ADDENDUM NO. 2

DATE: March 18, 2020
FROM: City of Grand Junction Purchasing Division
TO: All Interested Parties
RE: Outdoor Recreation Equipment Concessionaire Public-Private Partnership
RFP-4754-20-SH

D1 North Exterior Elevation
1/8" = 1'-0"

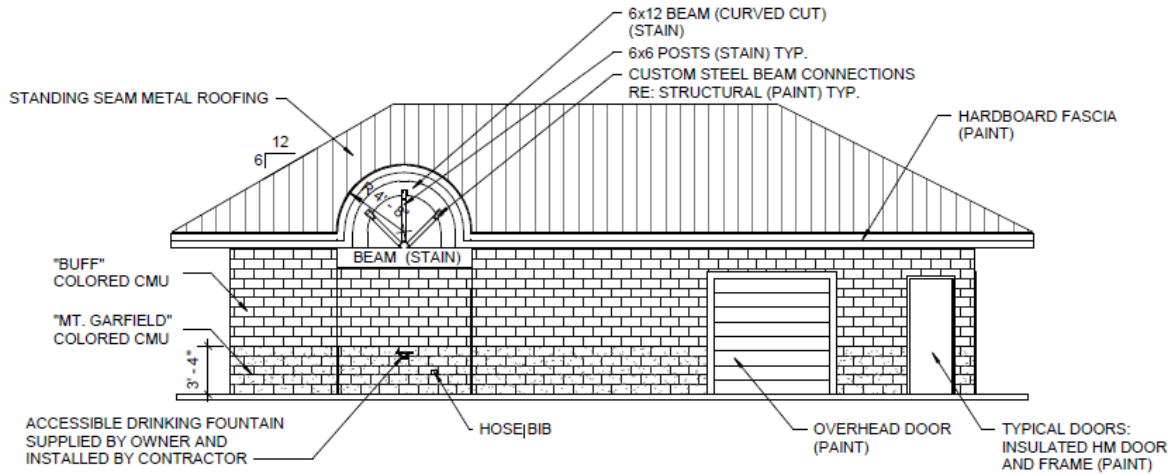
10. **Question:** "Where is the water spigot for washing off equipment and will a key be provided for spigot? Will lessee be able to attach fittings and hoses to use it to clean off rental equipment? Can the city install another one closer to the entrance of the kiosk? Will there be enough water for this?"

Answer: See below for hose bib location. Yes, the vendor will have access to this and be able to use whatever attachment desired. The City will not install another hose bib as the current one should be adequate.
